## LiDAR Quality Assessment Report

### SD\_Missouri-River-Lidar-Dewberry-B2\_2016

NGTOC

2018-06-28

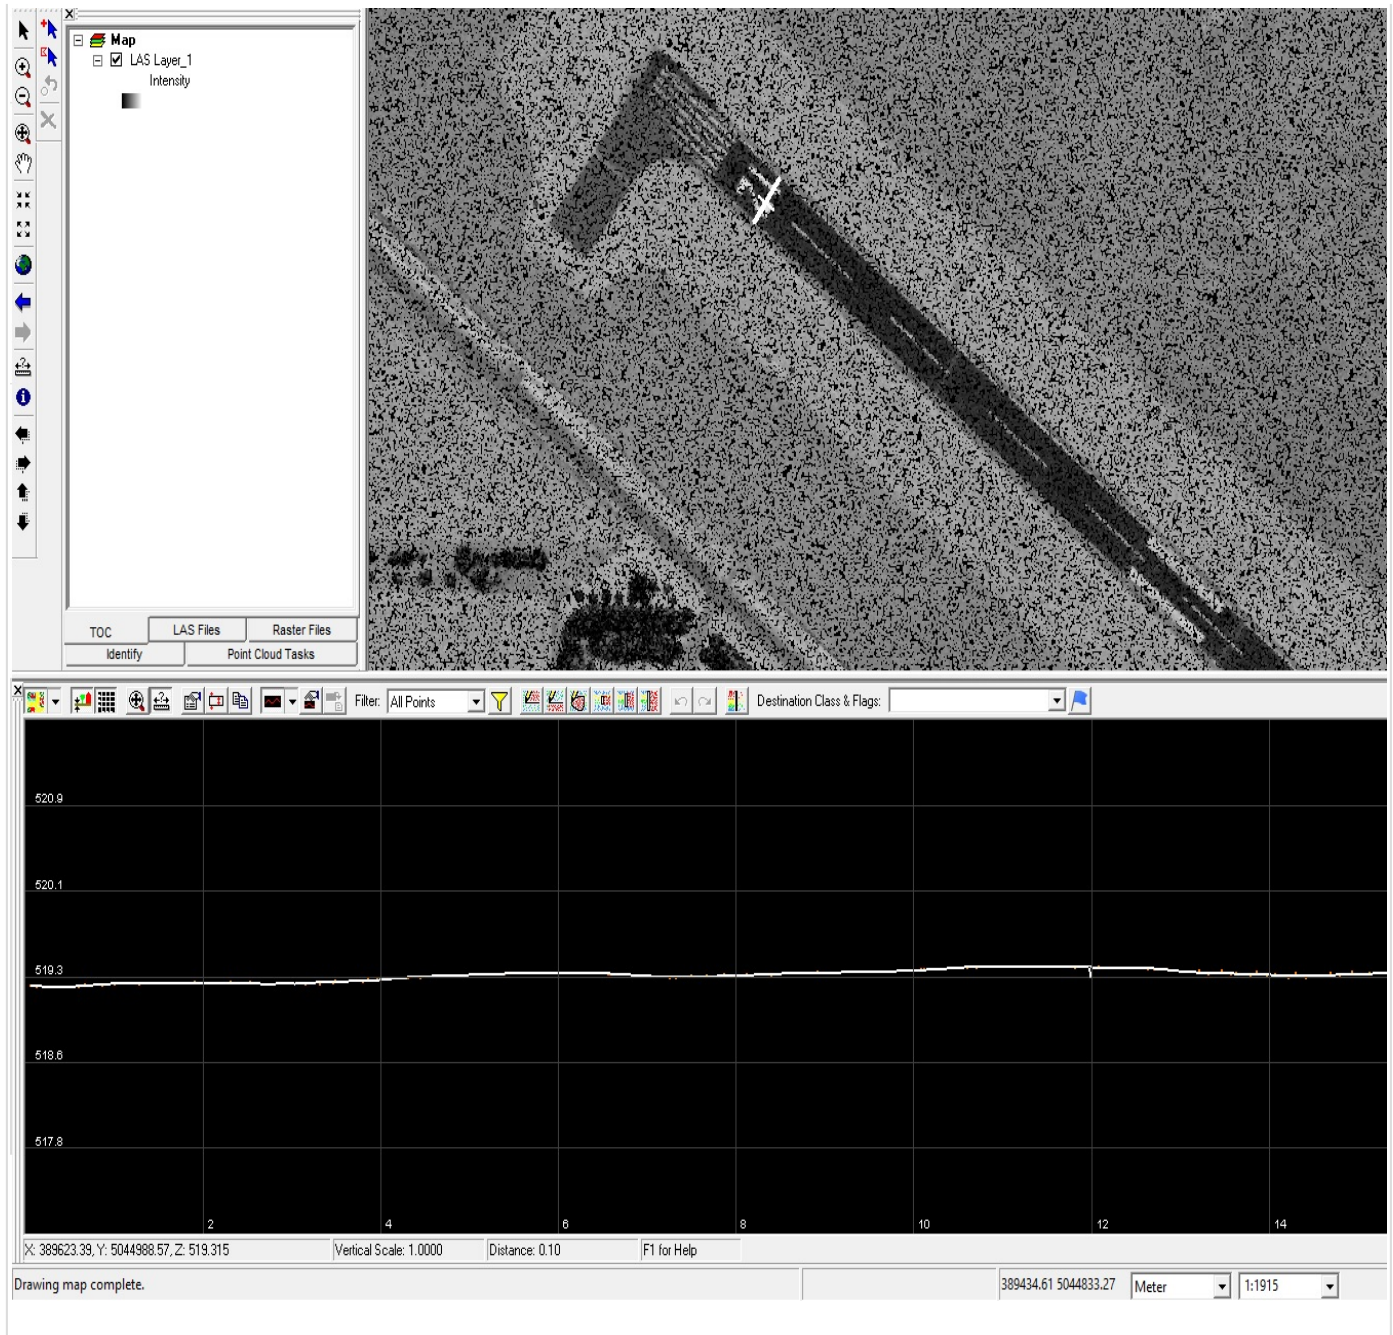
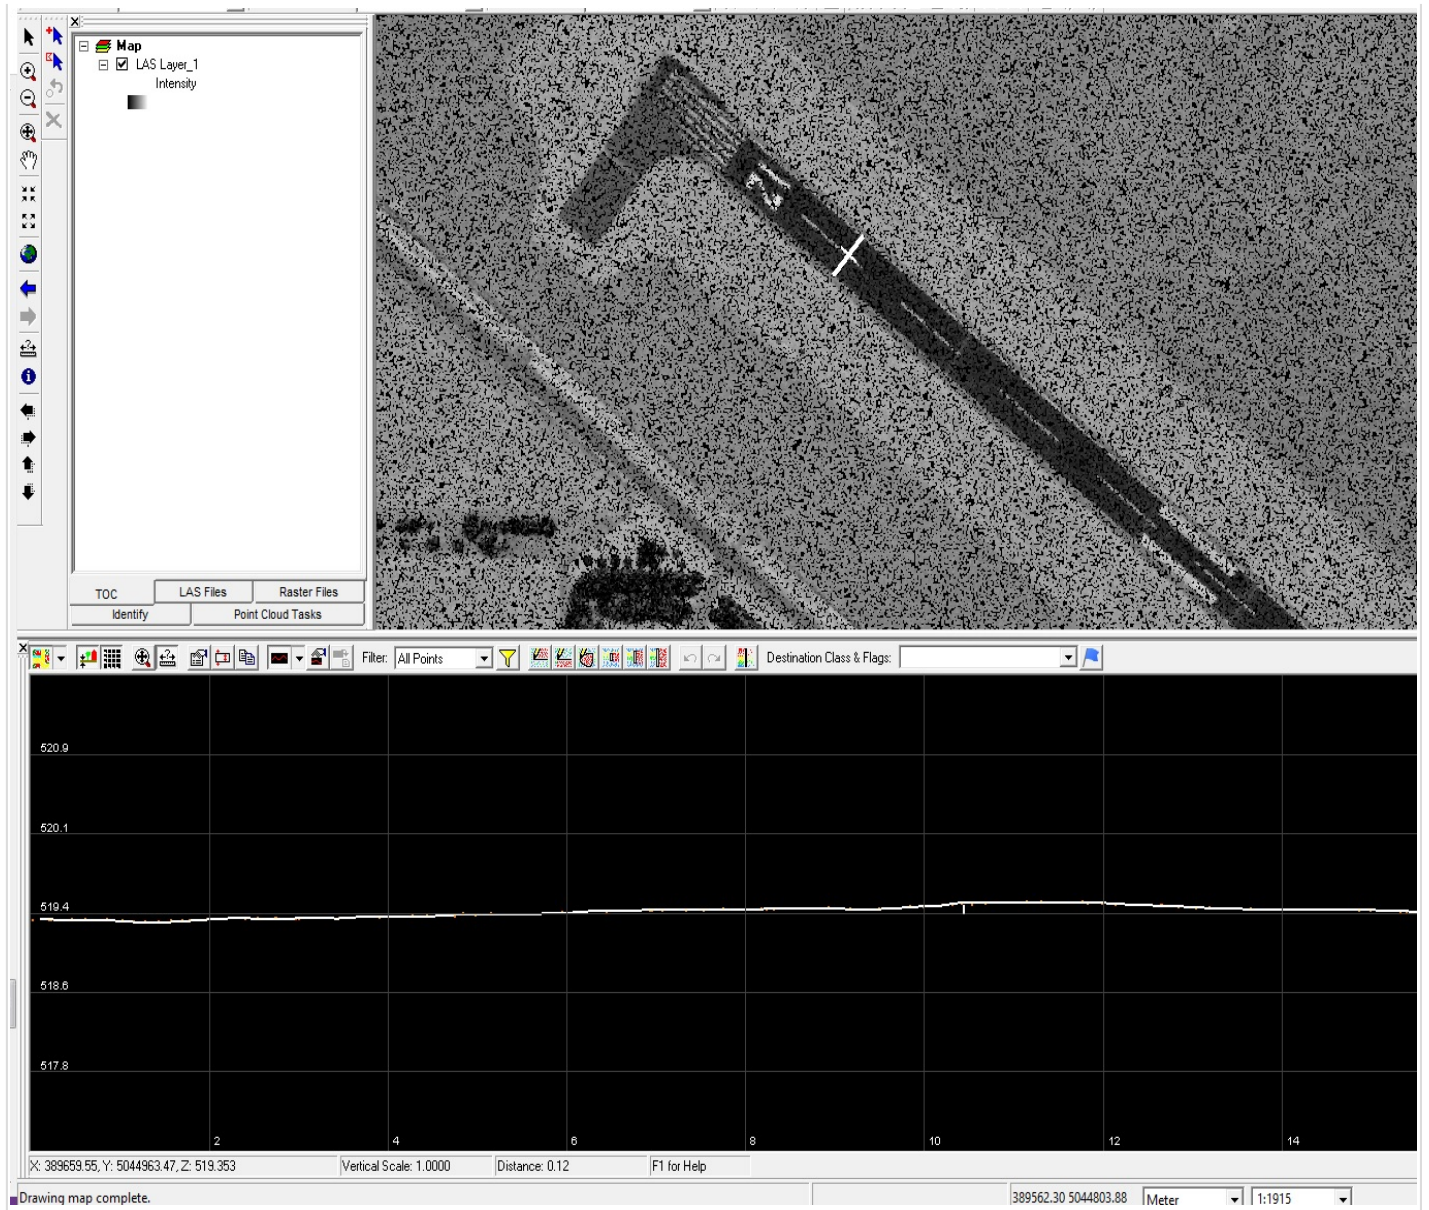
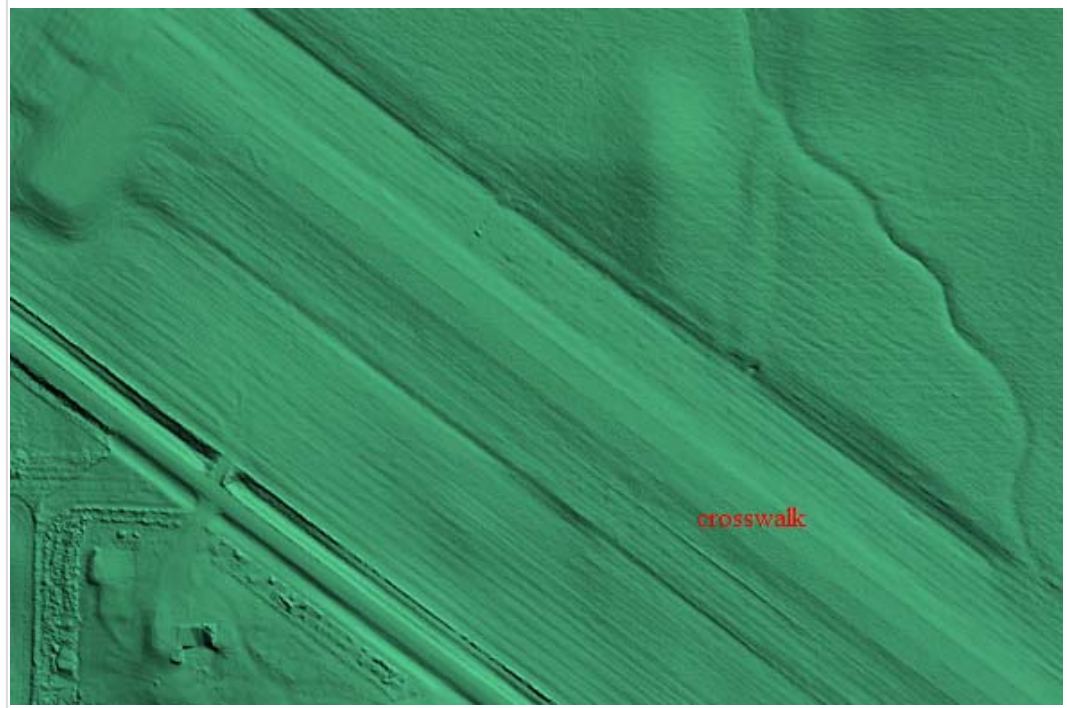
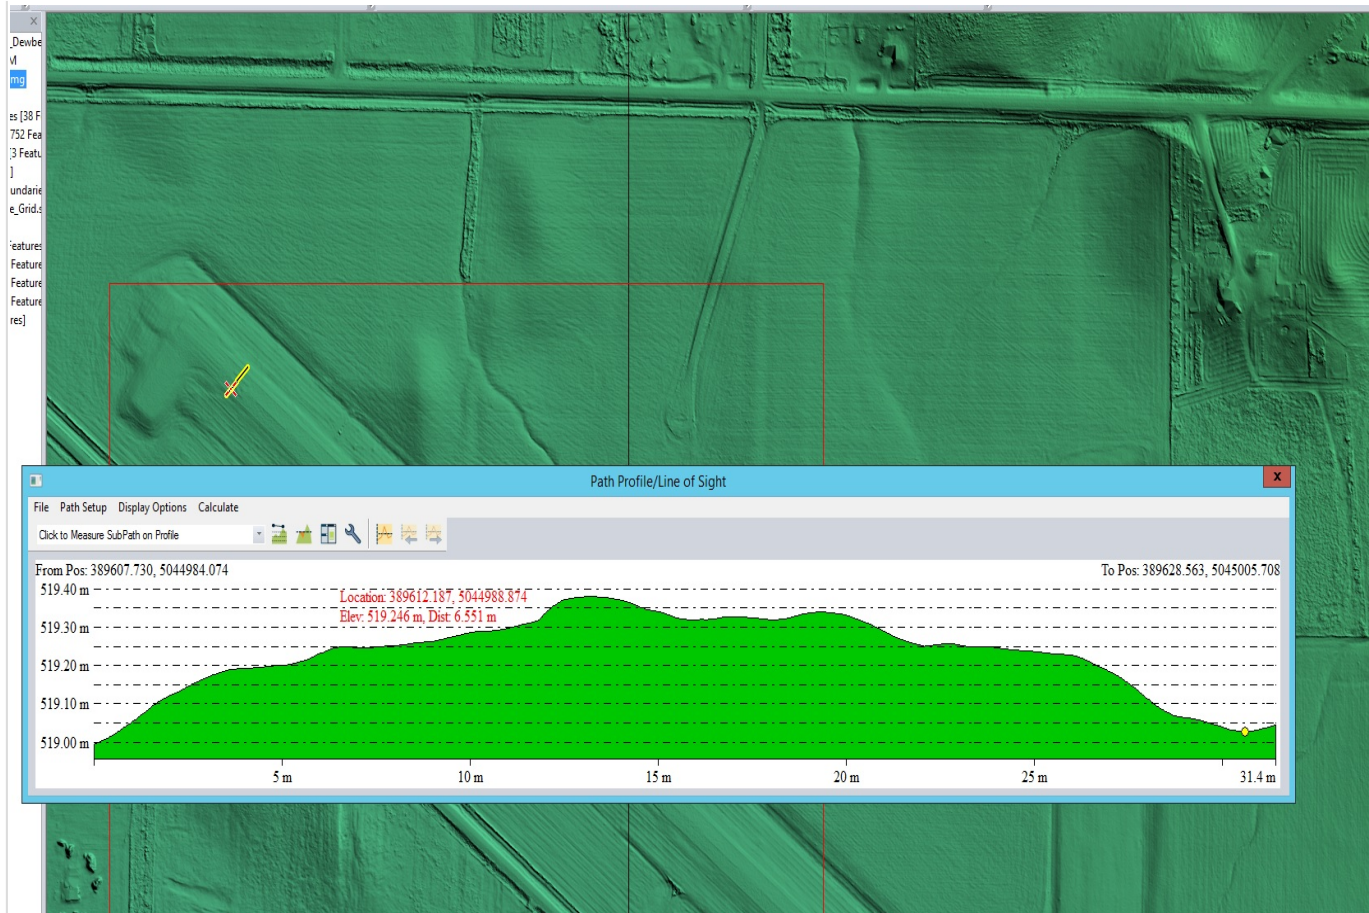
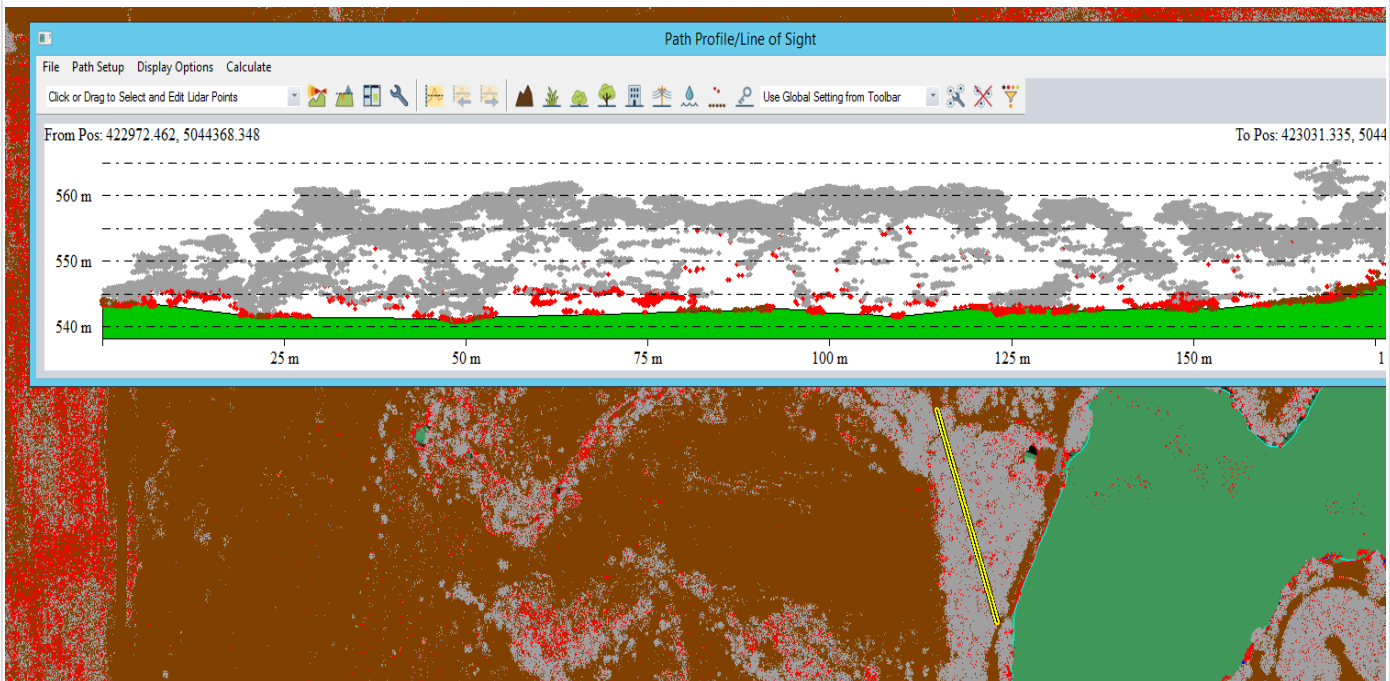
Tiles 14TLR38705044.img and 14TLR38905044.img contain point cloud obtained over Mobridge Municipal Airport (45° 32' 53.8880" N, 100° 24' 40.4293" W). Since range walk issues potentially could be expected in this area, the tiles were loaded into Global Mapper and LP 360 software to test both the point cloud and the corresponding digital elevation model (DEM).

The cross-section reveals approximately 10 -15 cm variance across the point cloud (1 meter profile depth) :

The DEM shows 15 - 20 cm vertical surface distribution.

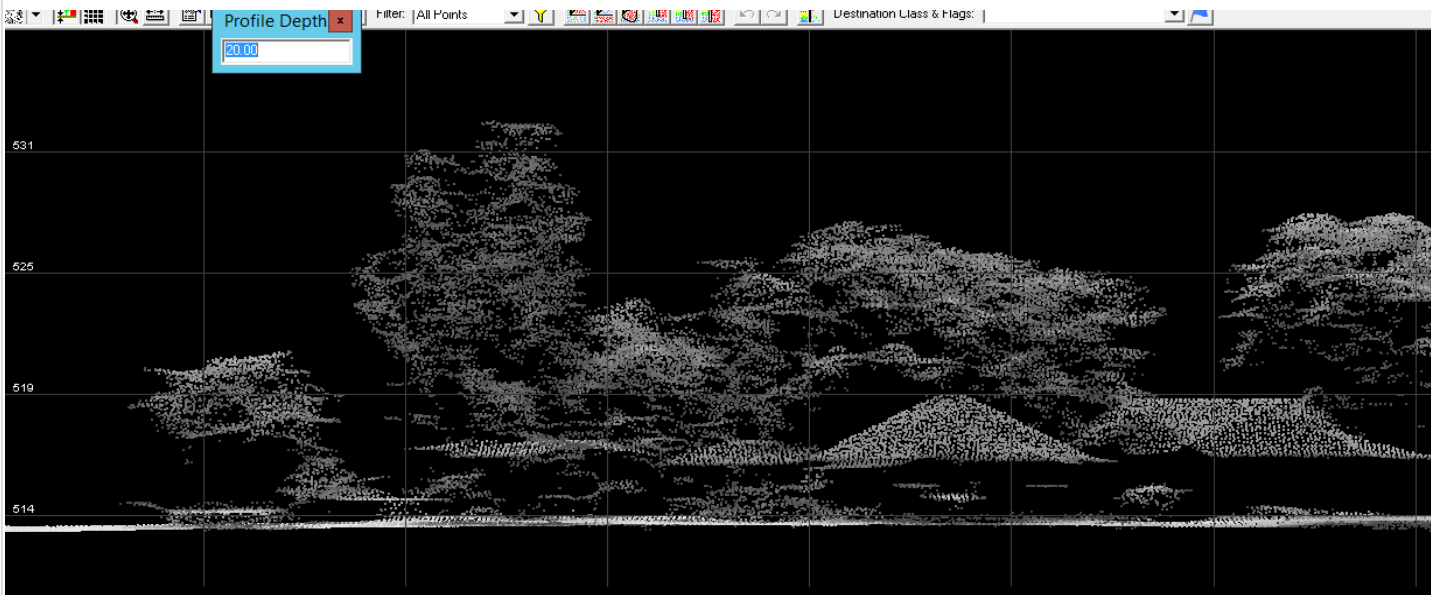
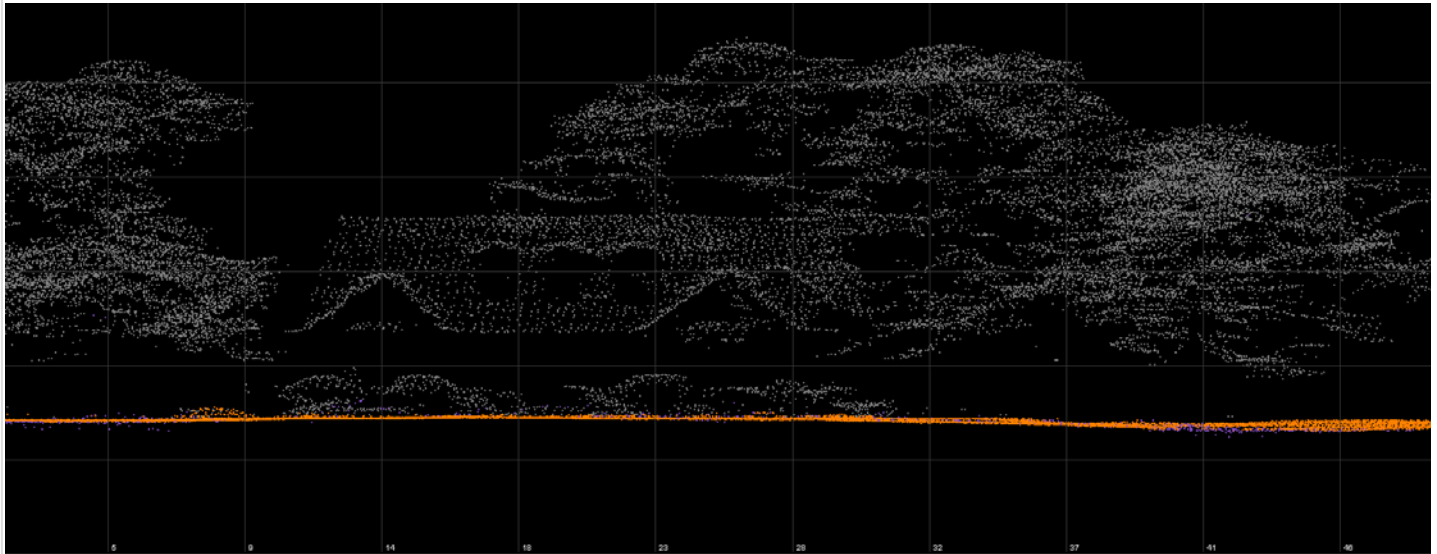
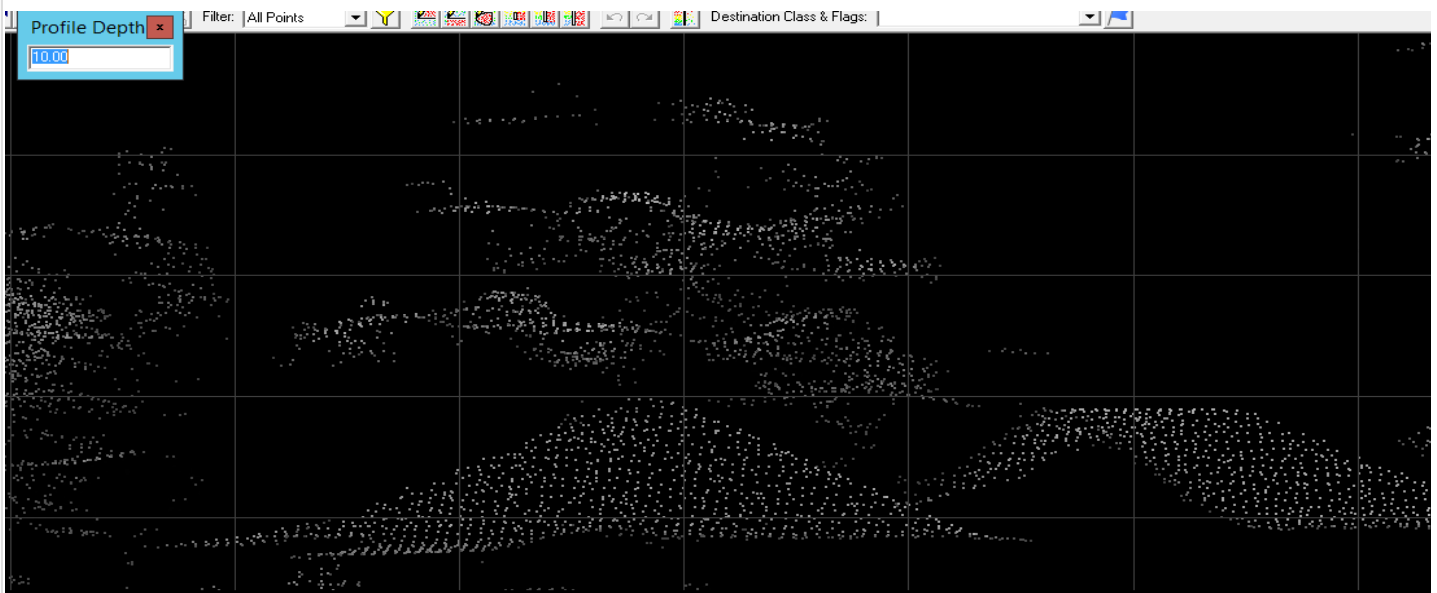
4) There are a few of areas of concern that present a reduced number of ground points resulting in aberrant, tinned spaces.
